ADDENDUM NO. 3

September 28, 2023

Whiteland Community High School Phase 1
300 E. Main Street
Whiteland, IN 46184

This Addendum consists of Pages ADD 3-1 through ADD 3-2, Specification Section 00 31 00 – Indiana Bid Form, Specification Section 01 21 00 Allowances, and Specification Section 01 23 00 – Alternates, Architects Addendum No. 3, consisting of 11 pages, Specification Section 03 37 00 Stained and Sealed Concrete Floors, Crossroads Engineers Narrative, 301, 302, 400, 500, 501, 1000, LS001, LS002, LS002, L601, S102AGH, A503, A504, A505, A731, Primary Engineering Narrative, P002, P100M, P101AGH, P101M, P403, P501, P504, E201M, E601, E701, E705, Design27 Narrative.

4 STOREFRONT JAMB DETAIL TYP.
SCALE: 1 1/2" = 1'-0"

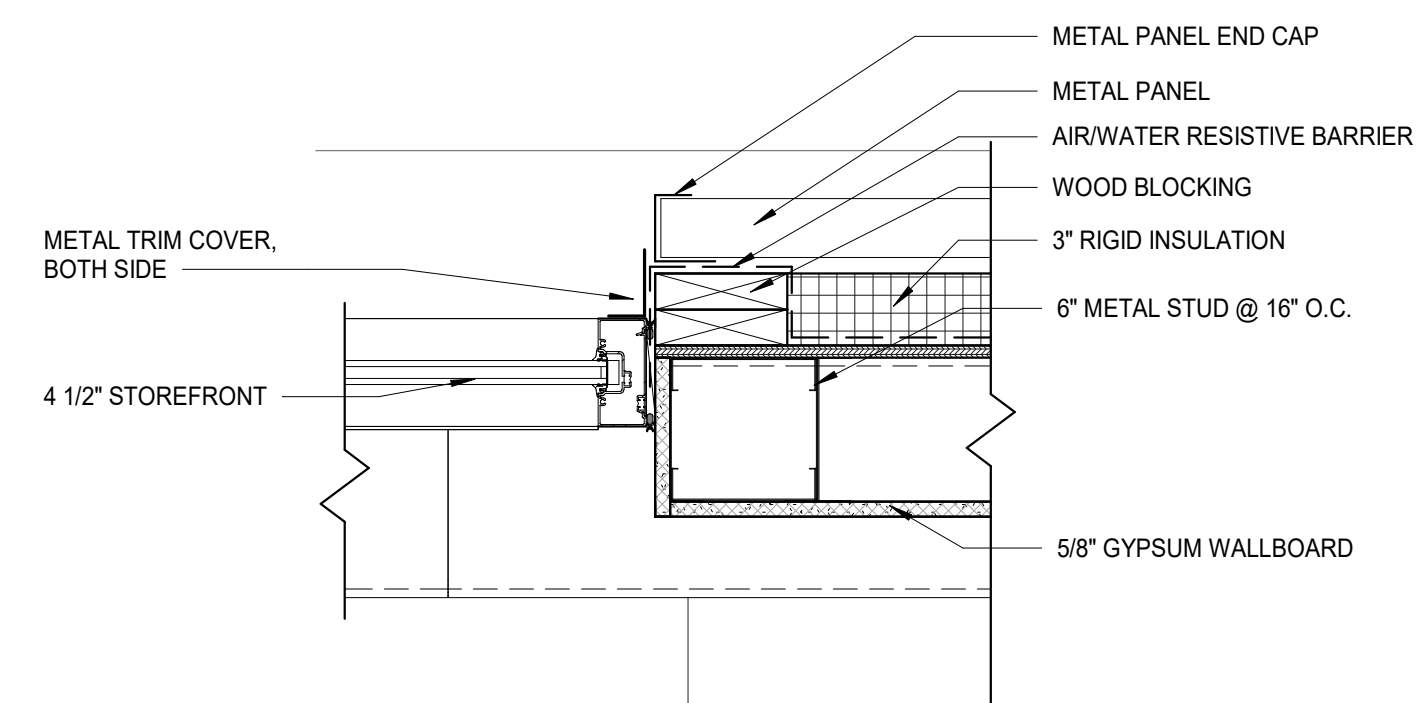
Revised Roof Detail 4/A503.

2 TYP. WINDOW HEAD @ 1ST FLOOR
SCALE: 1" = 1'-0"

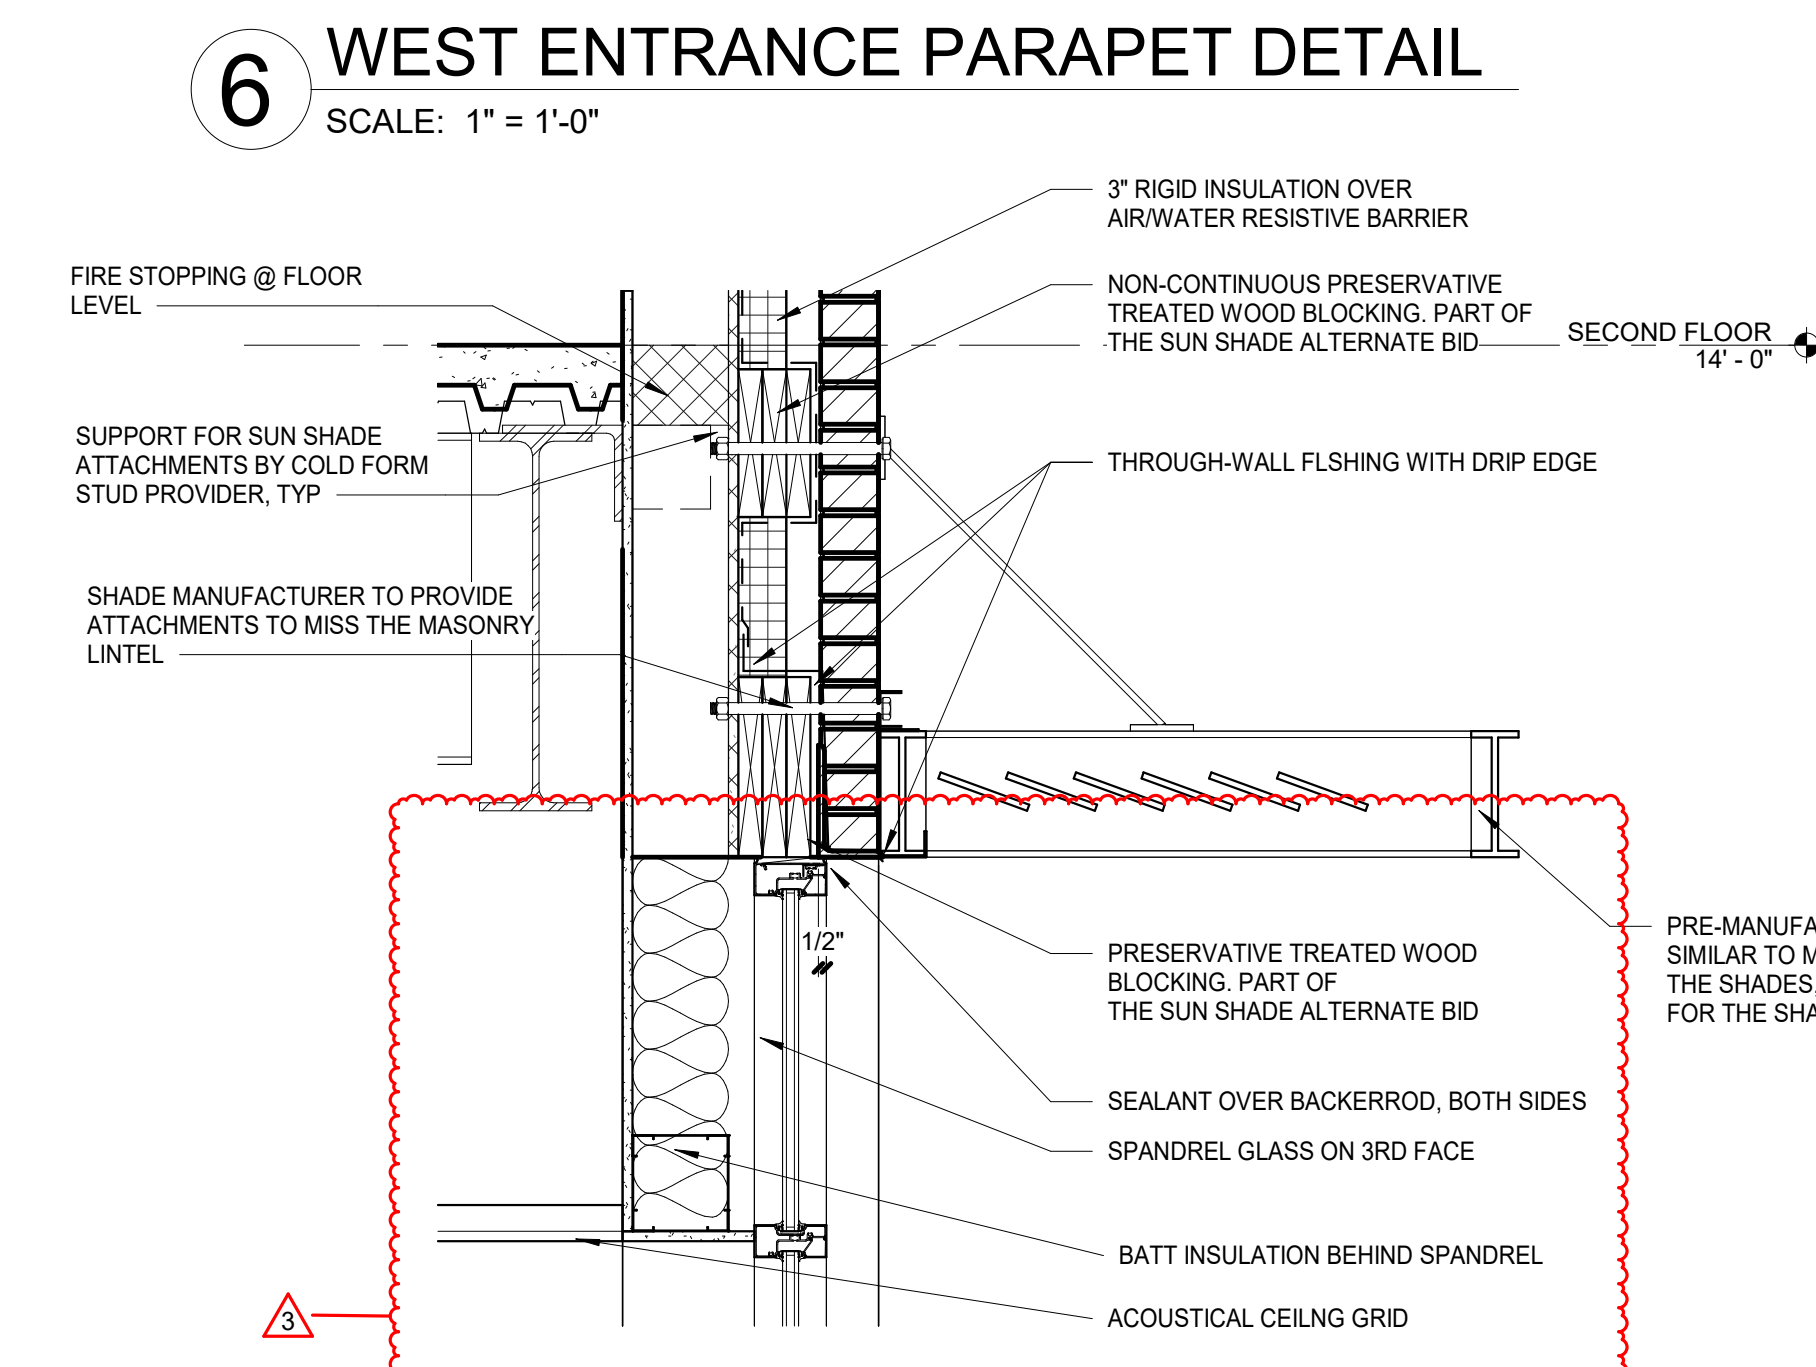
Q35: Typical 1st floor head condition detail 2 on A504. The storefront window terminates to the wood blocking.

Revised Roof Detail 2/A504 & 3/A504.

1 TYP. WINDOW HEAD @ 2ND FLOOR
SCALE: 1" = 1'-0"

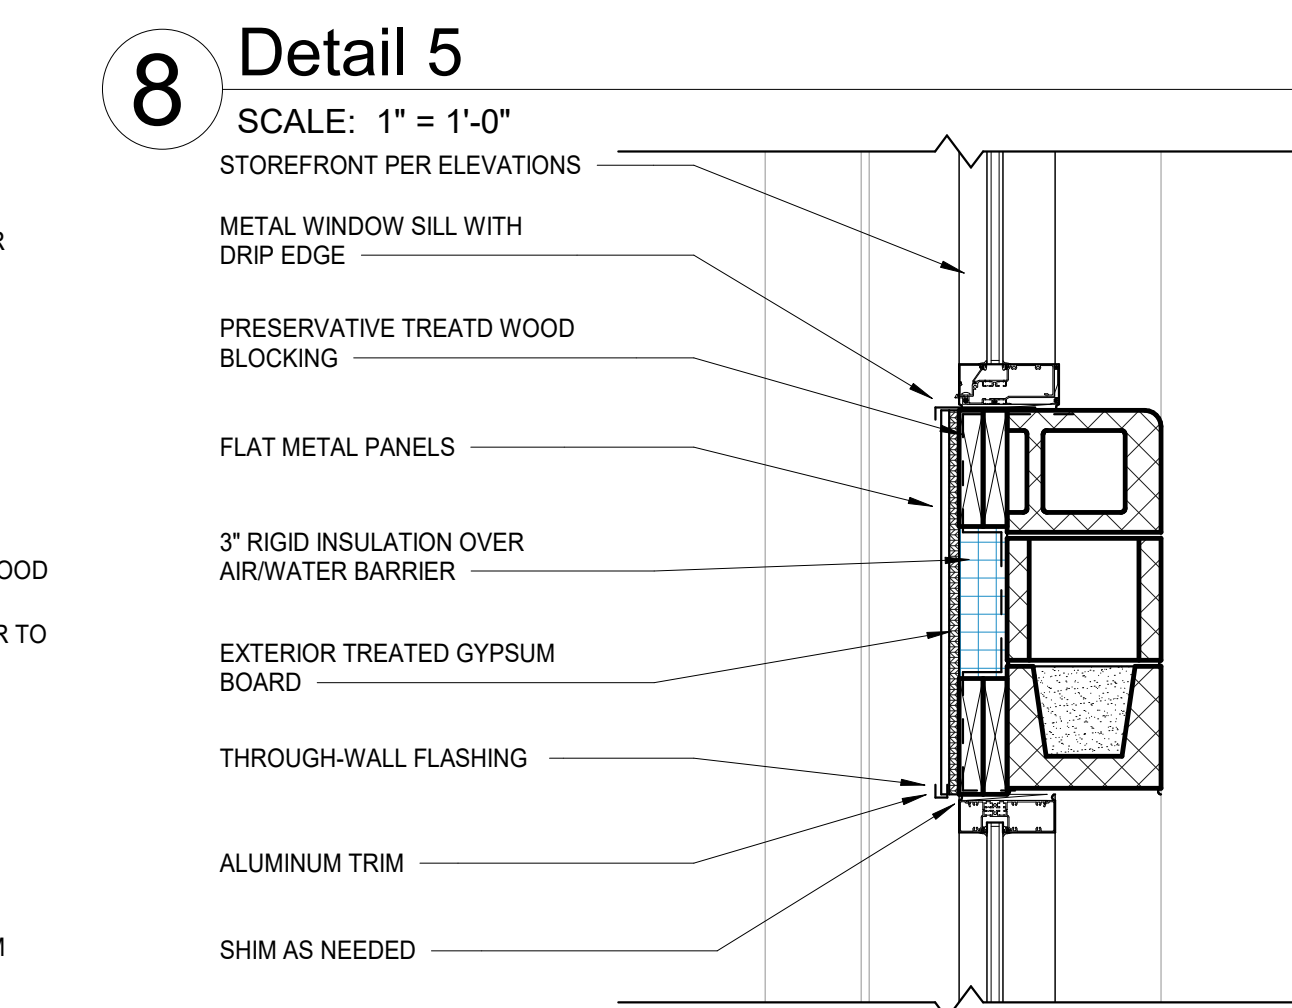
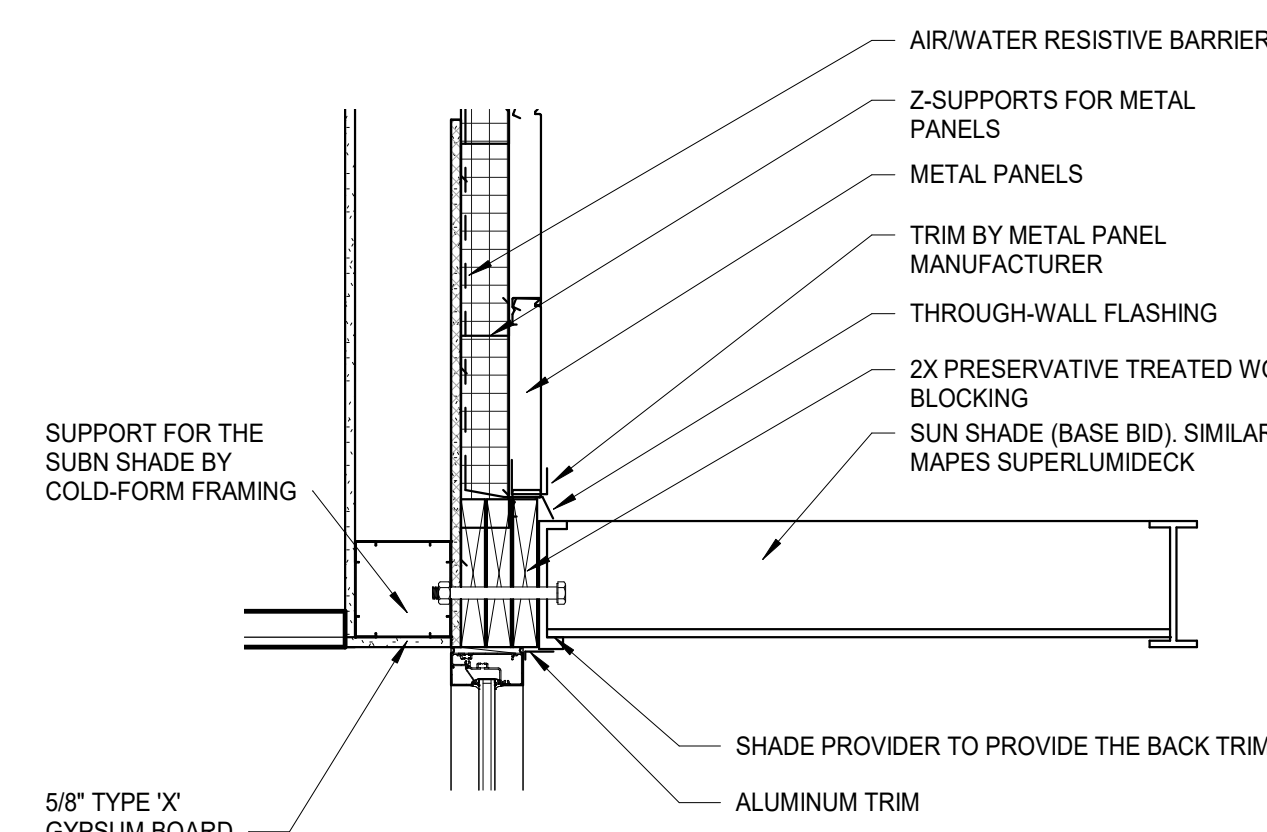
Q36: Typical 2nd floor head condition detail 1 on A505. Same

Q37: Typical 3rd floor head condition detail 2 on A505. Same

Revised Roof Detail 1/A505 & 2/A505.

16 DETAIL - TERRAZZO BASE
SCALE: 3" = 1'-0"

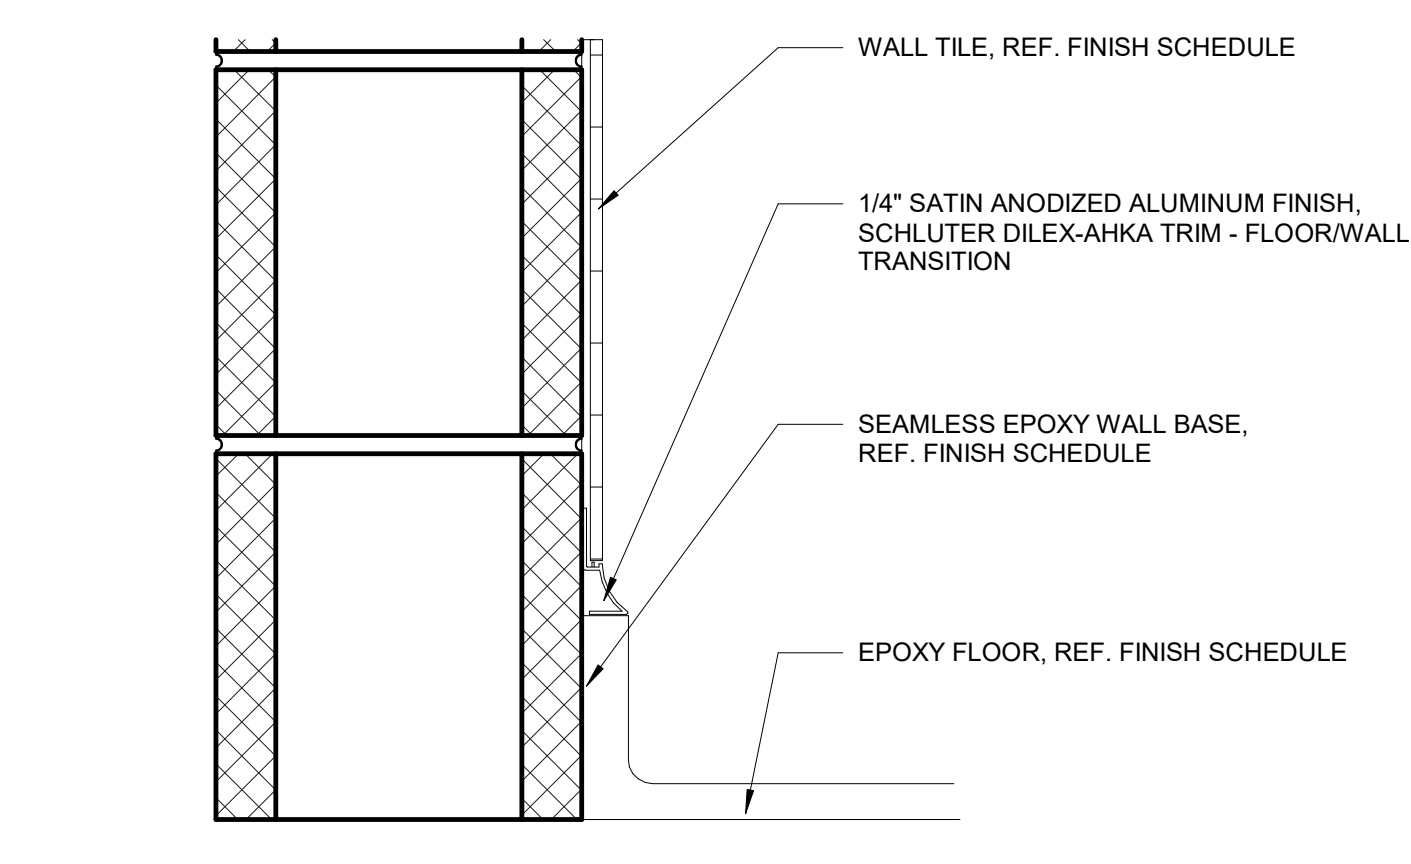
Add PRECAST TERRAZZO WALL BASE detail 16/A731.

01 INTEGRAL CONCRETE CURB & WALK
Scale: 1" = 1'-0"

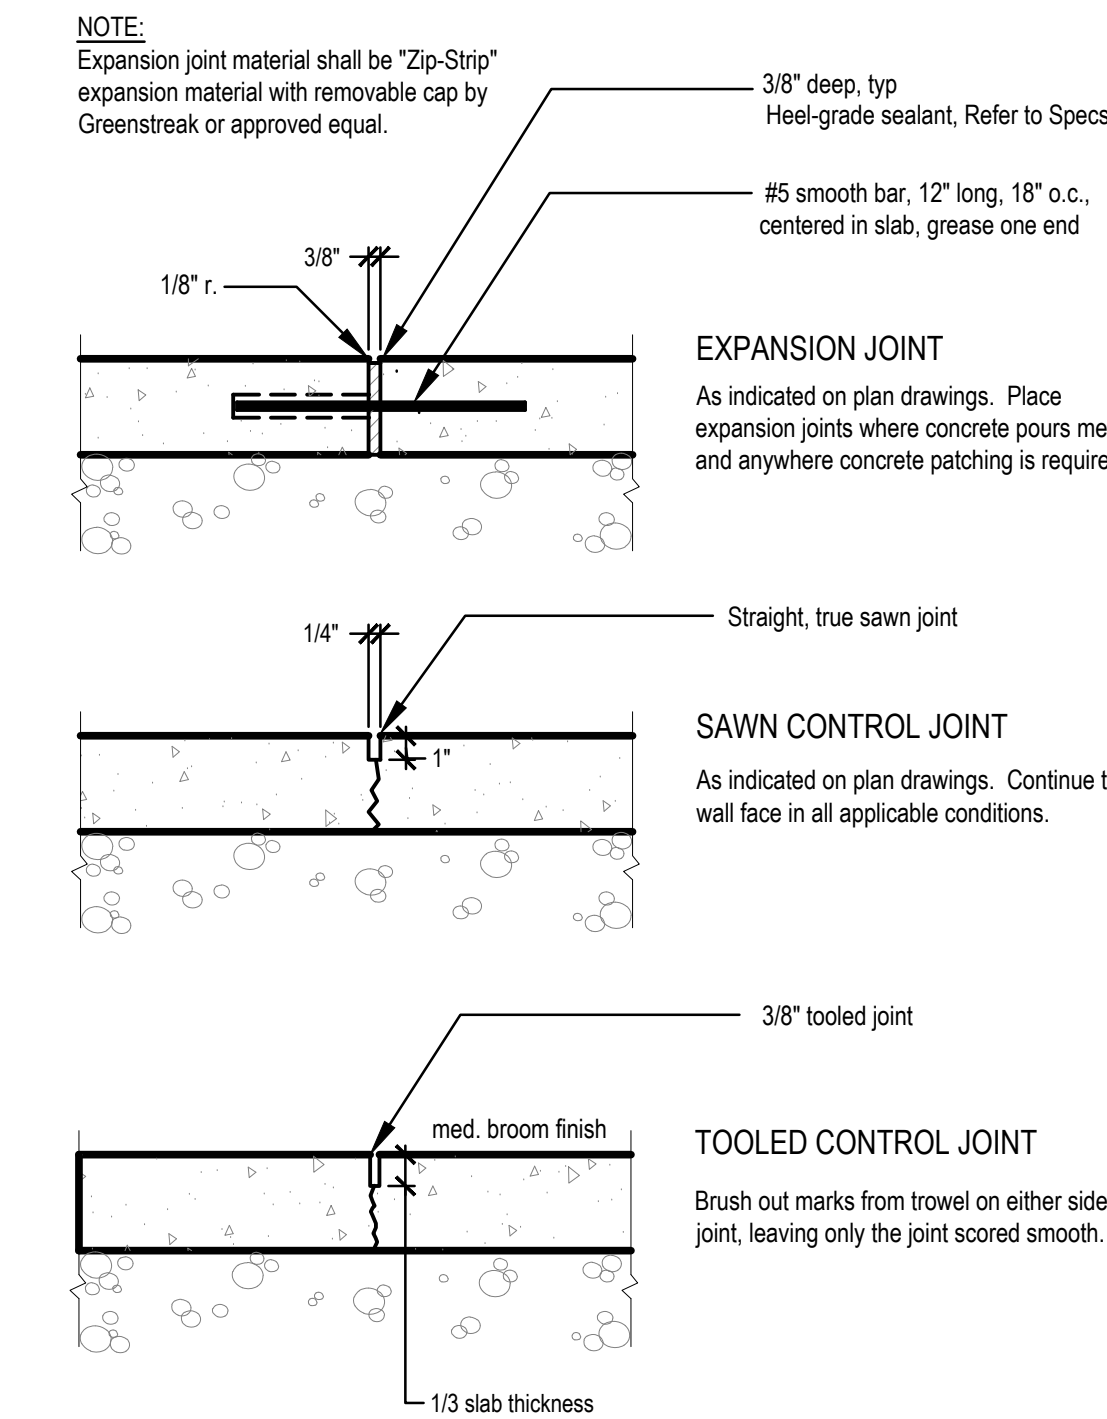
Detail 01: Detail was modified to show a 6" curb face reveal.
